ADDENDUM NO. 3

Project: Appalachian Regional Exposition (APEX) Center
290 Ready Mix Road
Fort Chiswell, Wythe County, Virginia

Date: September 29, 2017

PSK-2

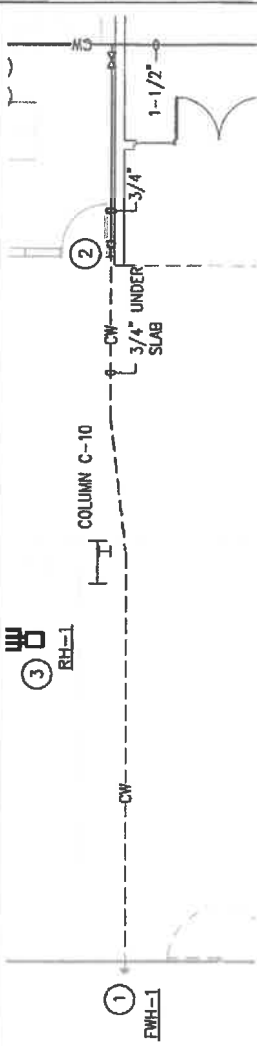
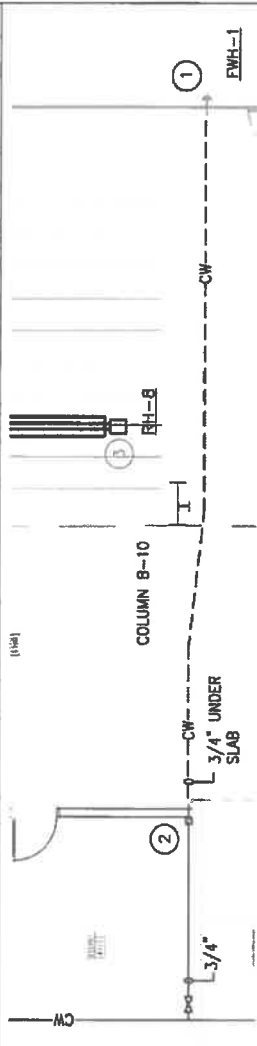
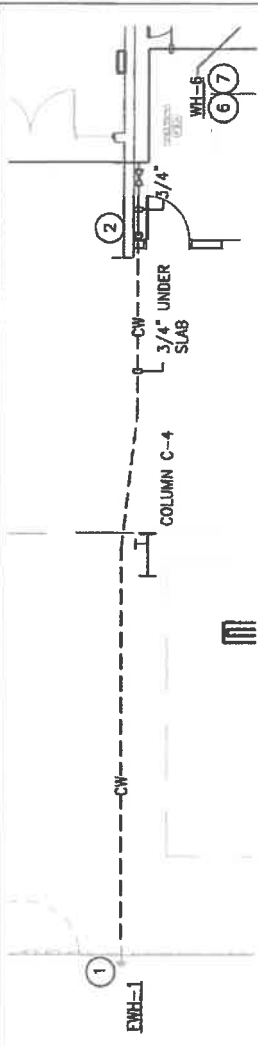
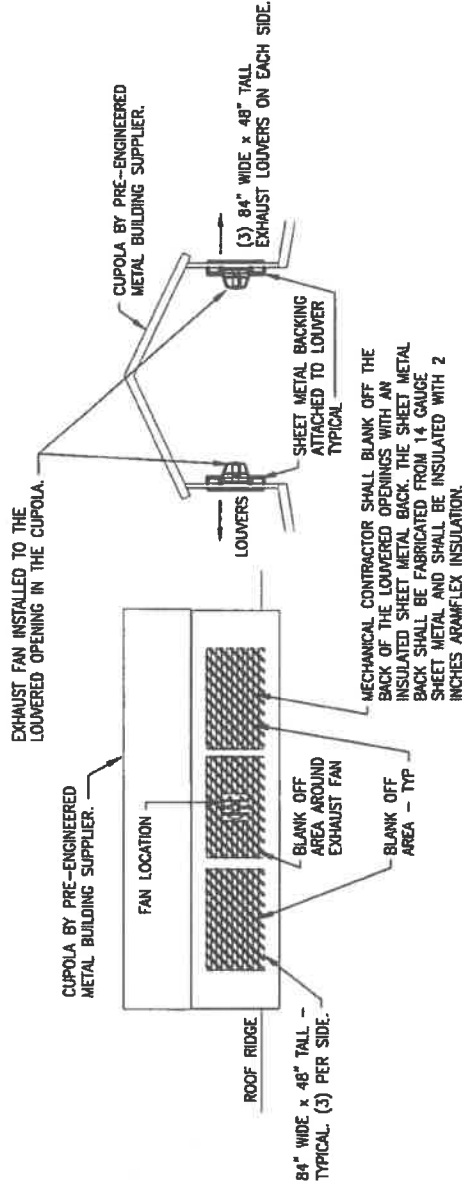
3. Sheets P101, P102, P105, & P106 – PLUMBING PLANS

Four (4) interior wall hydrants shall be added as shown in Sketch PSK-2 recessed in the concrete wall at the sides of the Performance Area. They will serve to provide a water access for dust suppression in the Performance Area. Please note that this work will involve some portion of the water lines to these hydrants to be installed below the slab. The contractor shall coordinate the routing of these lines with all footers and other structural items. Water lines below the slab shall be Type K copper pipe. Type K copper water lines that penetrate concrete structures shall be insulated where in contact with the concrete.

- ① FREEZE PROOF WALL HYDRANT SHALL BE CONCEALED IN A BOX THAT IS PROVIDED.
- ② DROP 3/4" CW DOWN THRU FLOOR AND ROUTE UNDER SLAB TO WALL HYDRANT LOCATION, TYPICAL
